Approved Section 4.55 (.....2.....) Modification Application

Project
BARANGAROO STAGE 1B
PUBLIC DOMAIN
Modification S4.55

Drawing Title
**HICKSON PARK WEST ENTRY
DETAIL PLAN - NO TREES**
Drawn
SS

Sheet No19..... of55.....

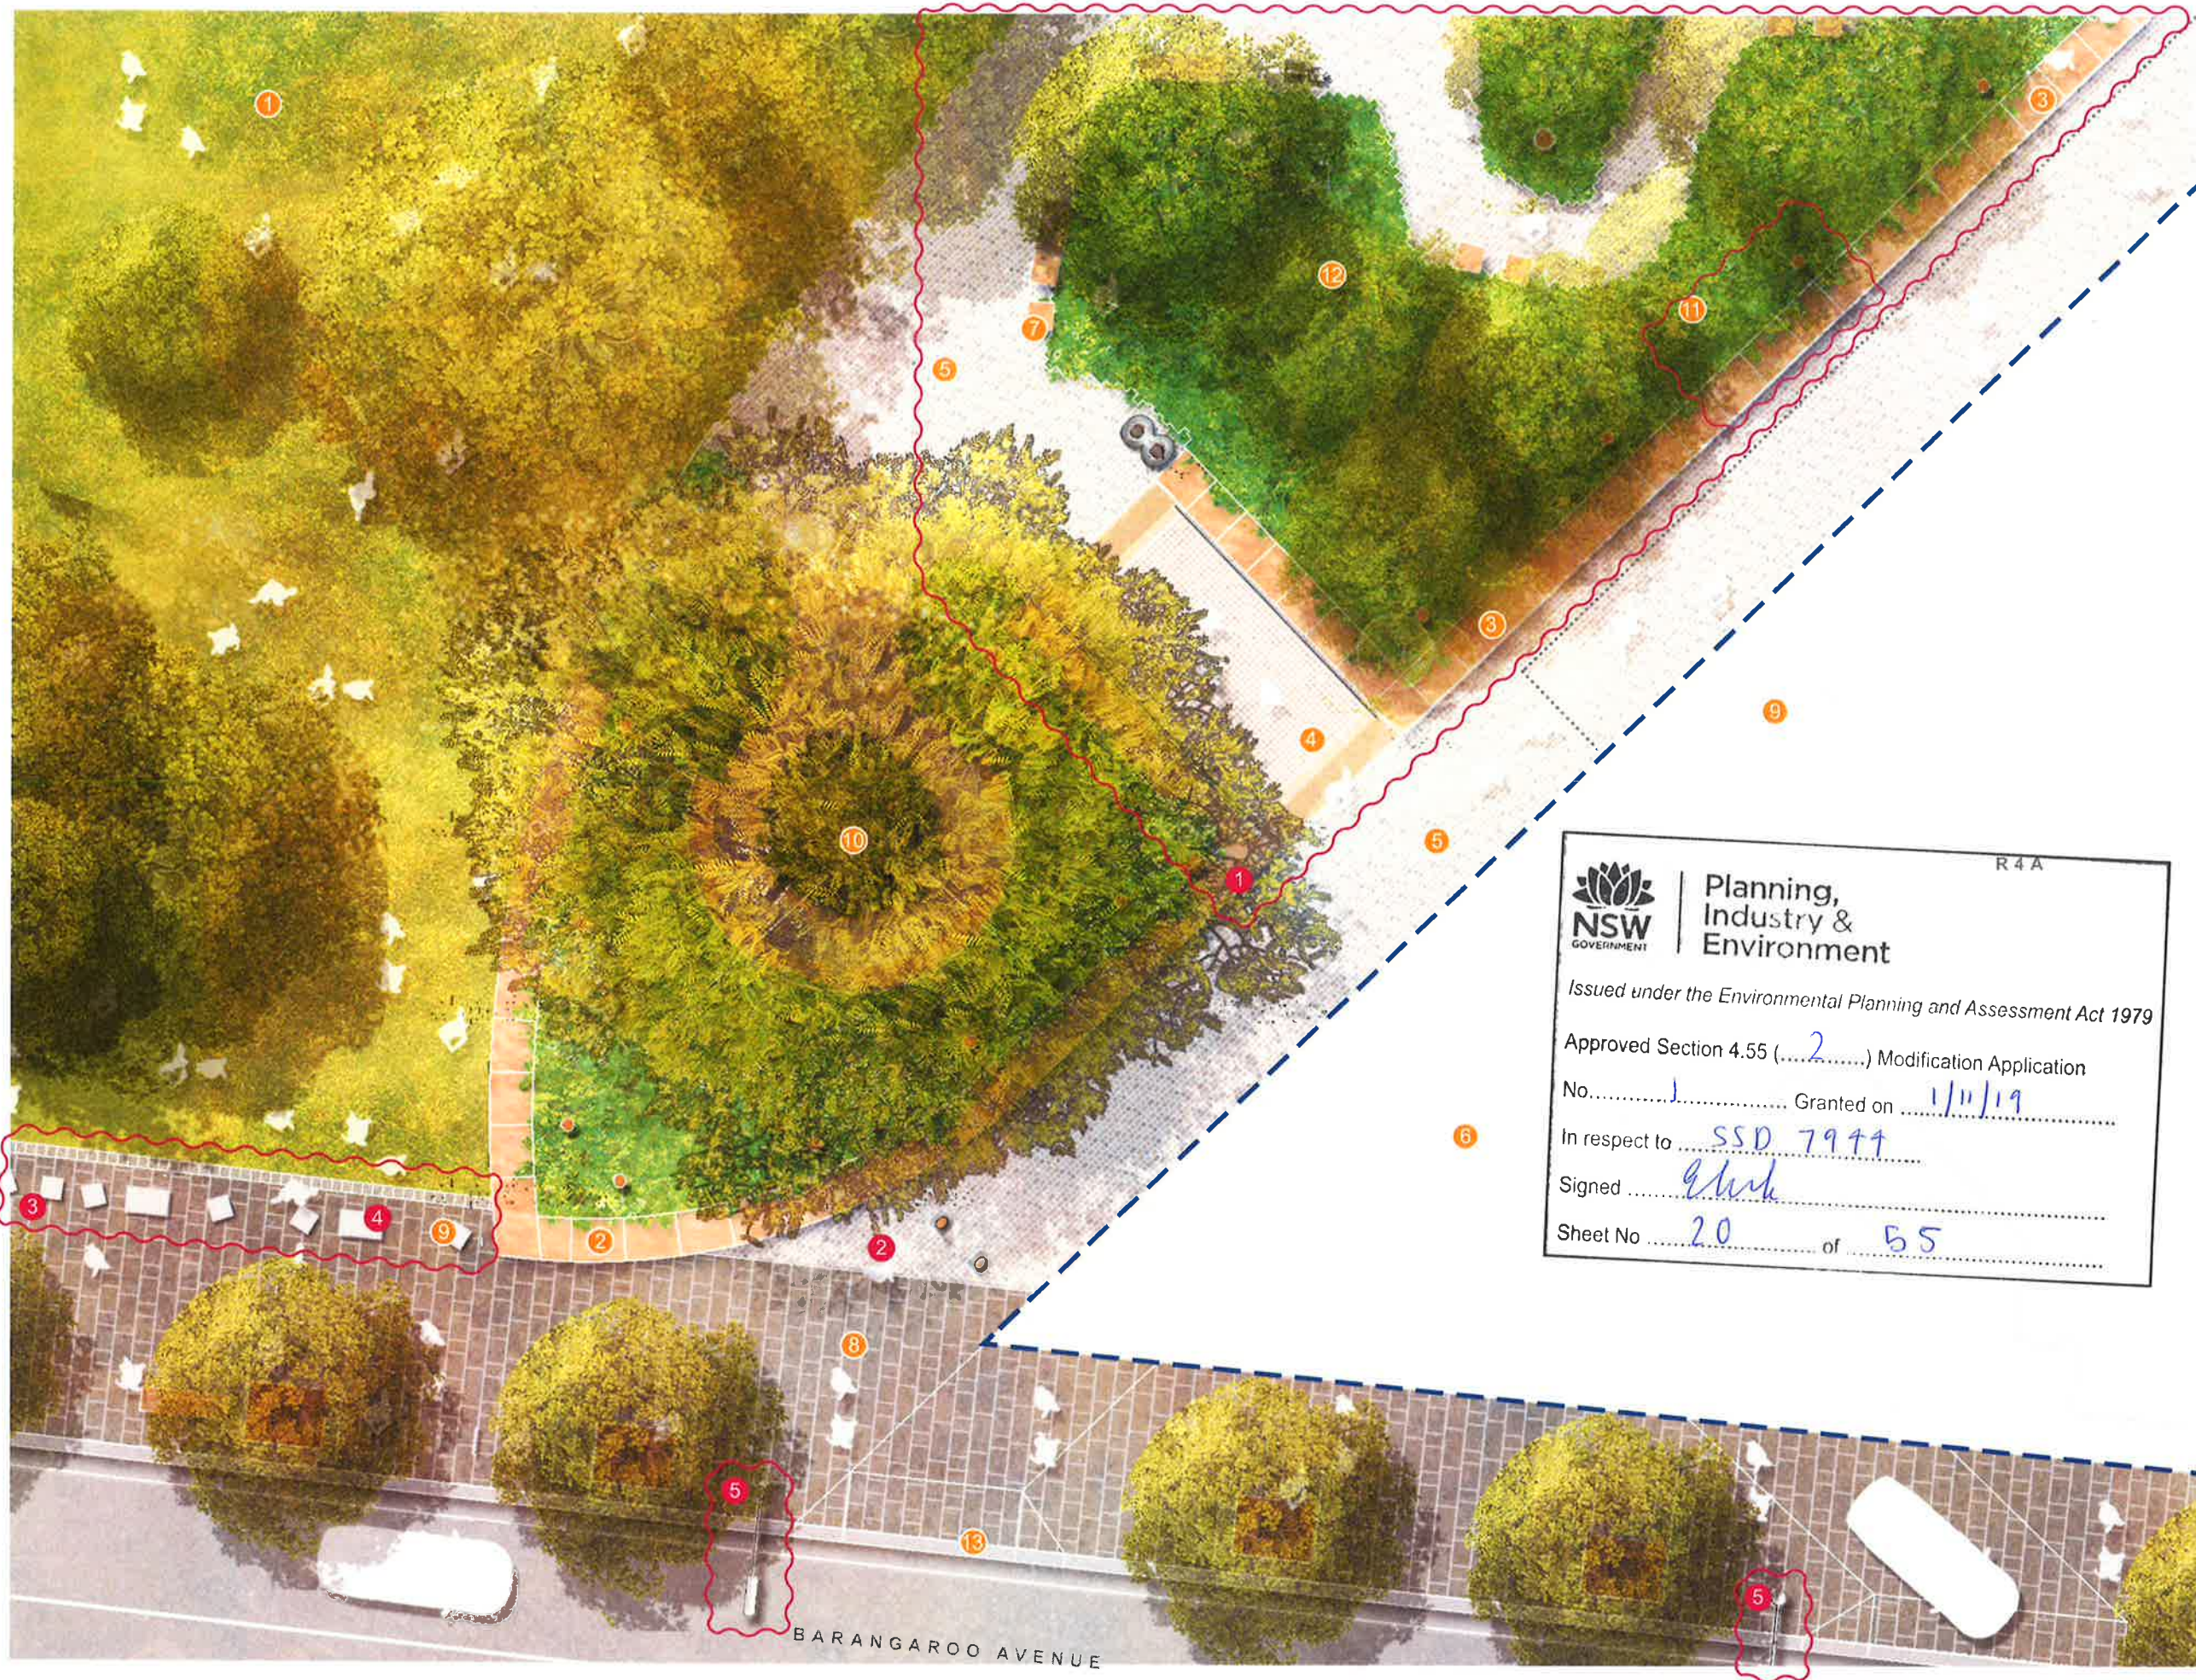
- Proposed Modifications**
- Amendment cloud
 - 1 Increase planting area within the park, change of geometry and move 1no. access stairs.
 - 2 Remove ramp and sandstone wall due to proposed Hickson Road levels
 - 3 Remove timber top for Watermans Quay raised planter seating
 - 4 Levels changed due to proposed Hickson Road levels

Planning, Industry & Environment
NSW GOVERNMENT
R 4 A
Issued under the Environmental Planning and Assessment Act 1979
Approved Section 4.55 (.....2.....) Modification Application
No.1..... Granted on 1/11/19
In respect to SSD 7944
Signed [Signature]
Sheet No 21 of 55

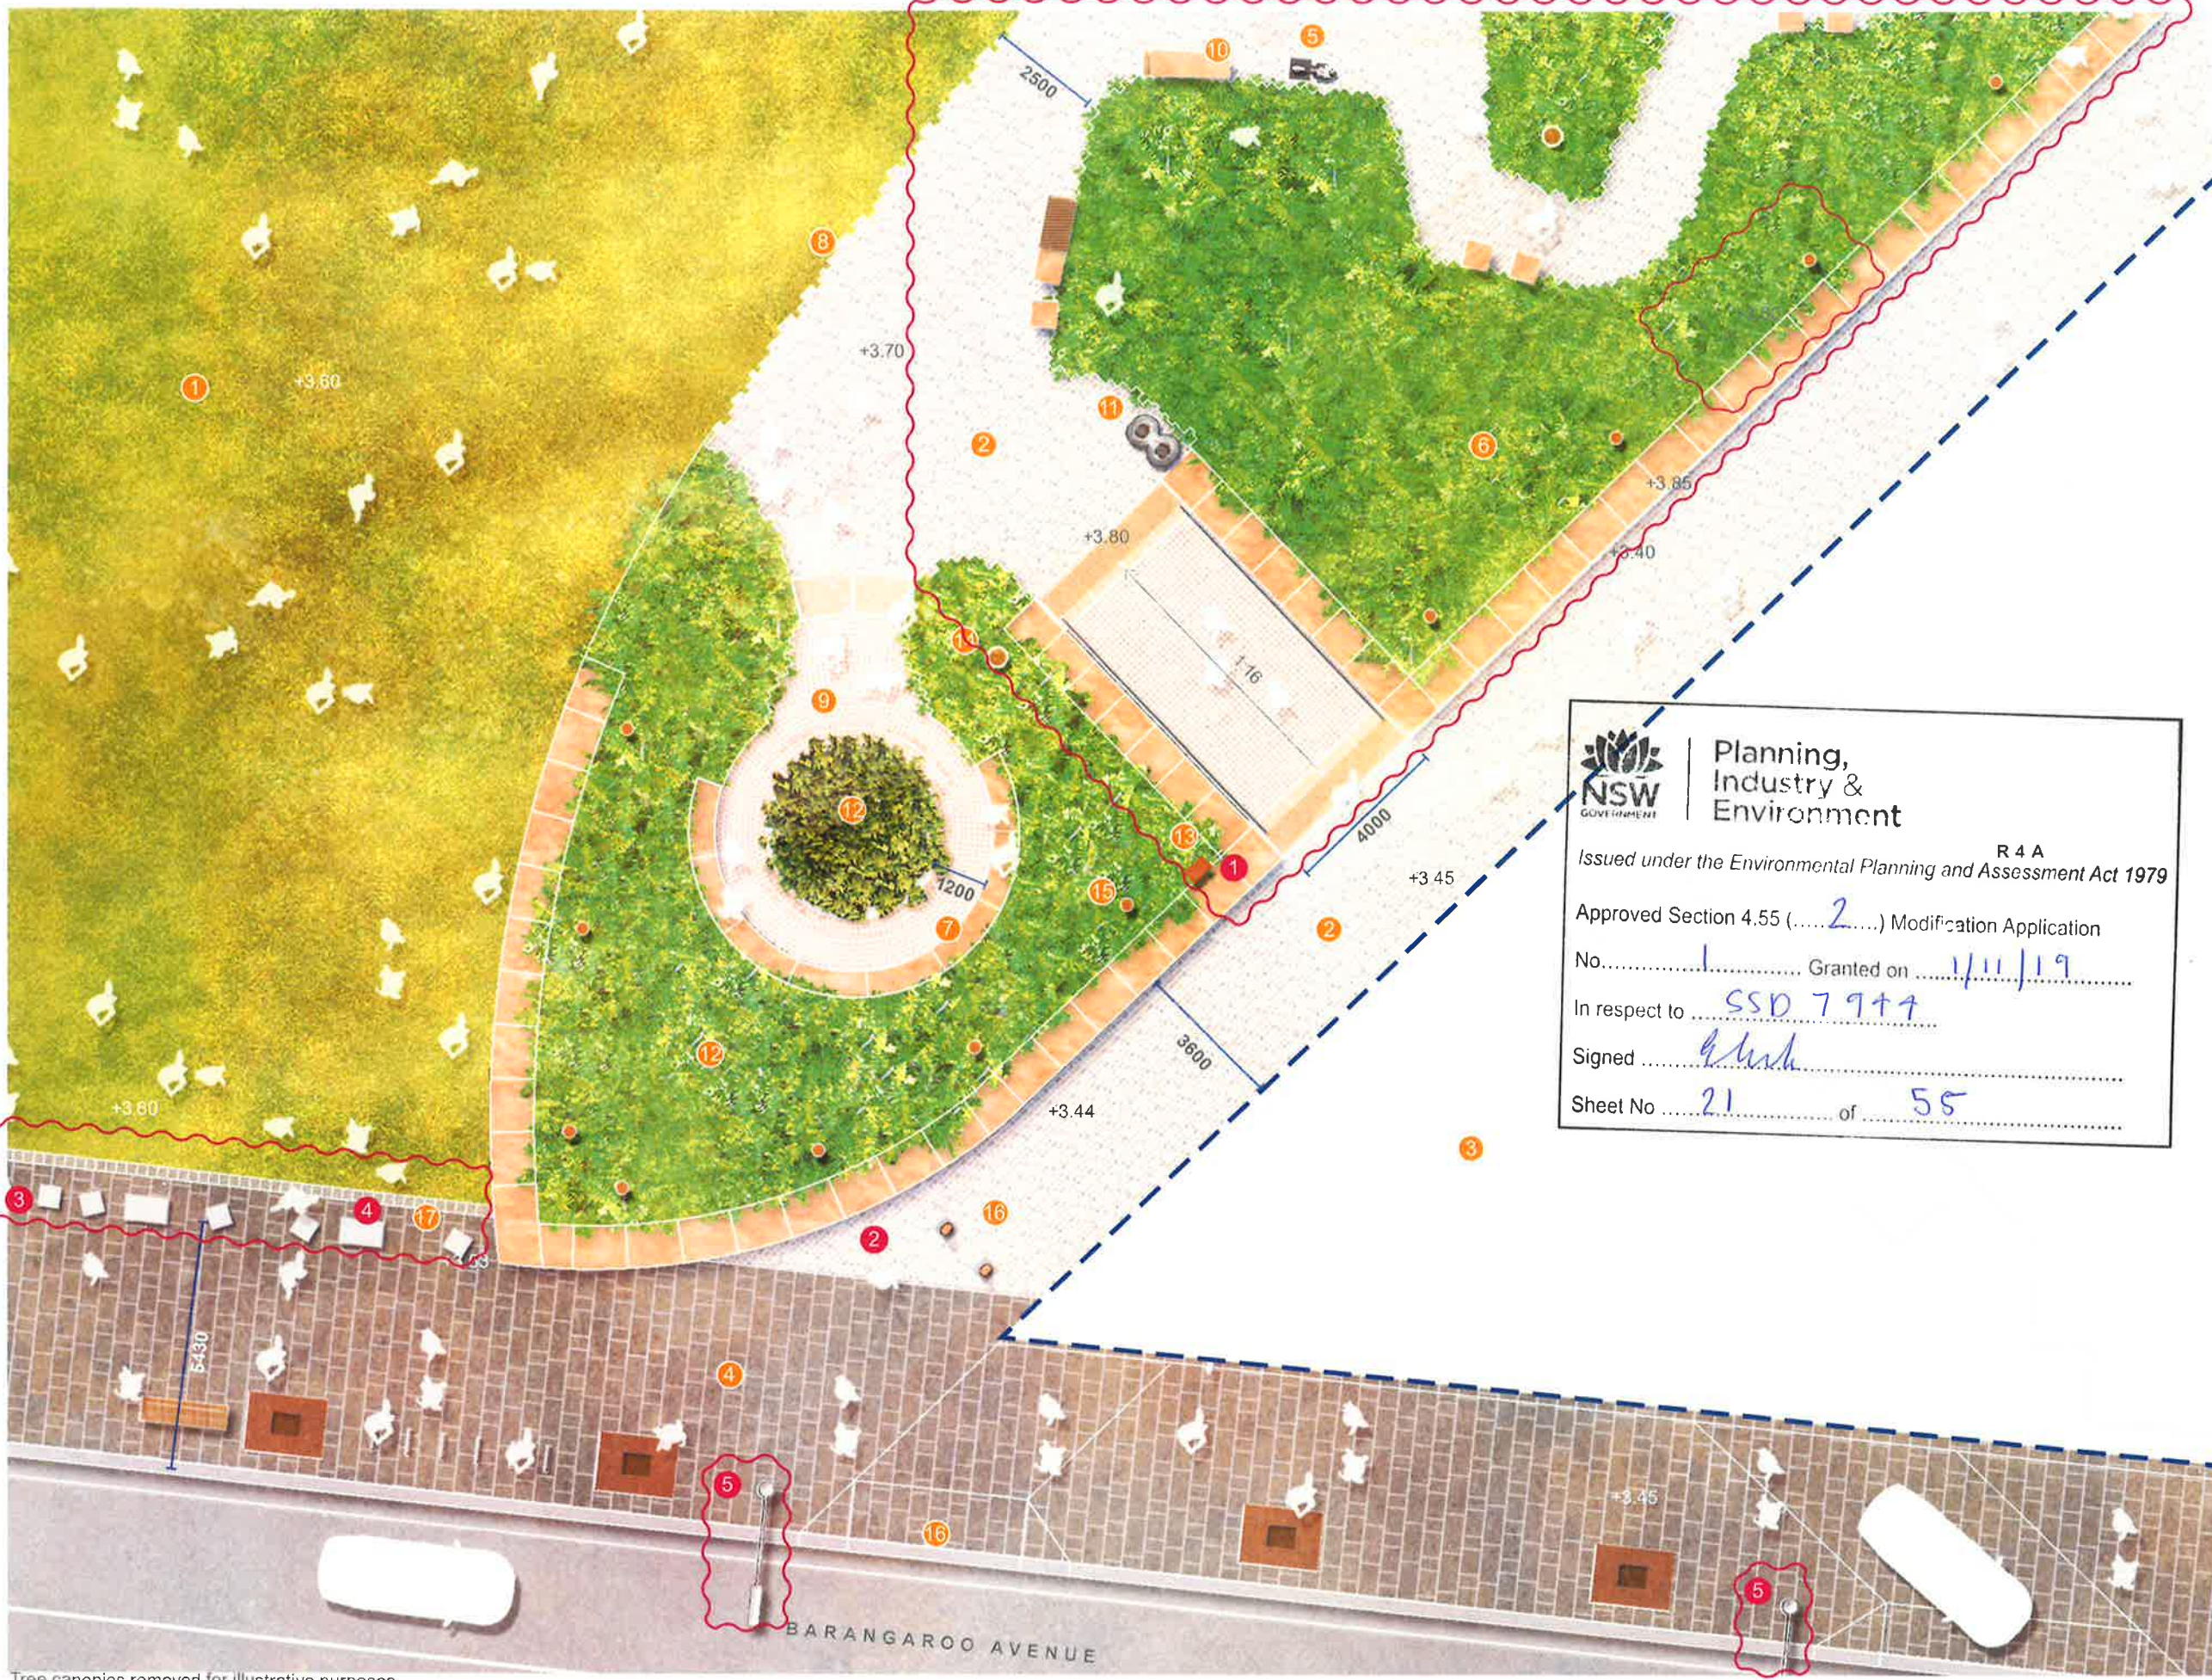
- Proposed Modifications**
- Amendment cloud
 - 1 Increase planting area within the park, change of geometry and remove 1no. access stairs.
 - 2 Remove porphyry paving to City of Sydney transition as per consent requirement B23
 - 3 Sandstone paving strip changed to City of Sydney paving along Hickson Park
 - 4 Sandstone bollards changed to concrete & setout amended.
 - 5 Additional smart pole

Sheet No23..... of55.....

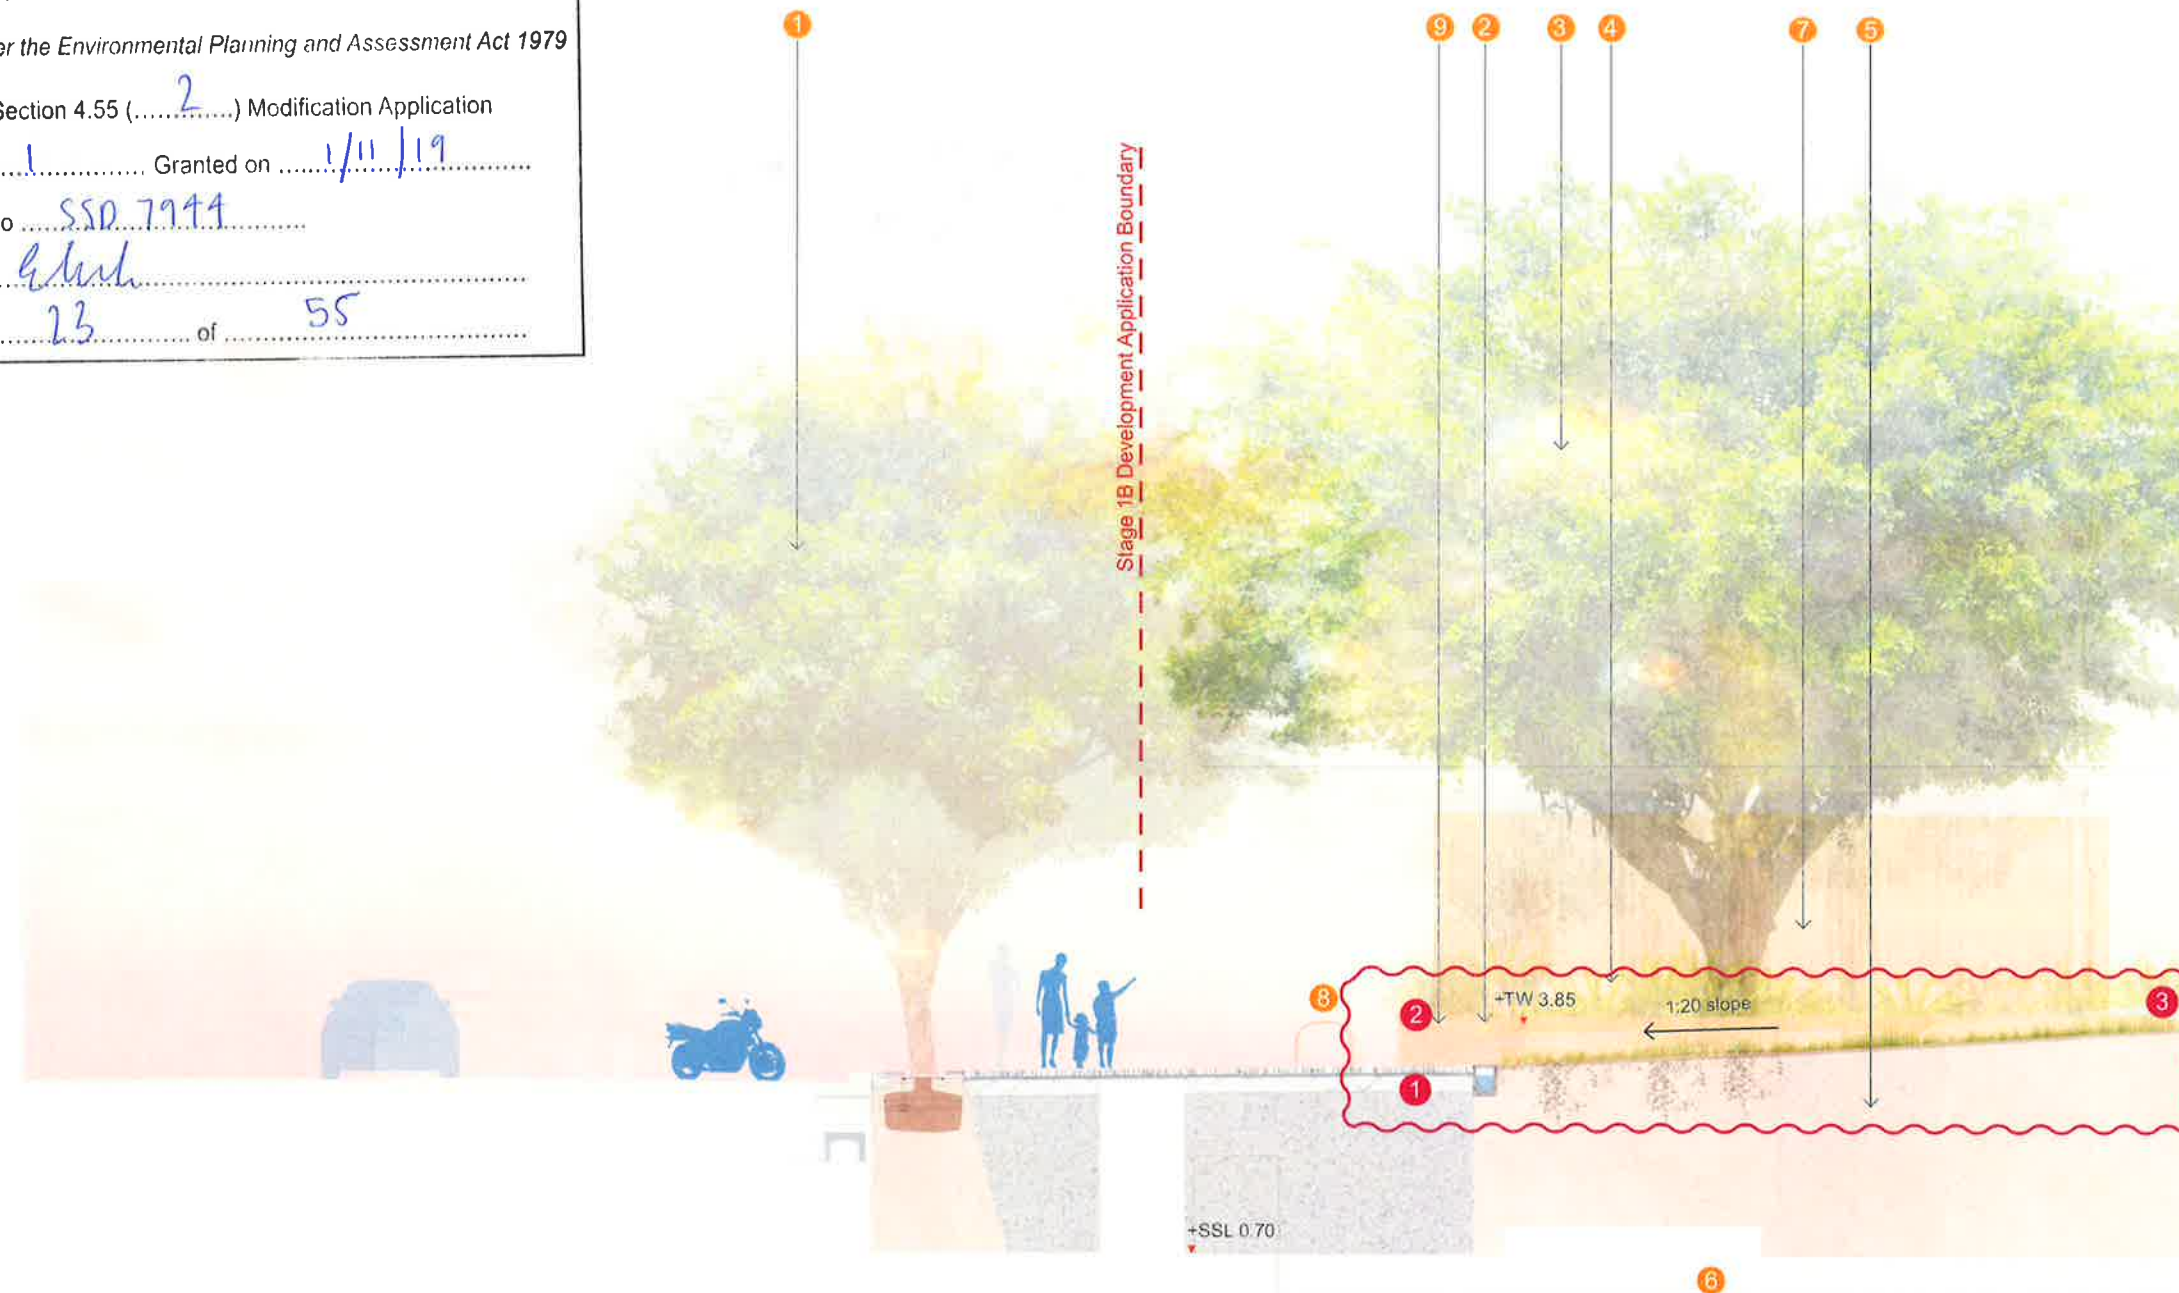
-  Amendment cloud
- 1 Sandstone paving strip changed to City of Sydney paving along Hickson Park
- 2 Delete bollards to East park edge
- 3 Levels changed due to proposed Hickson Road levels
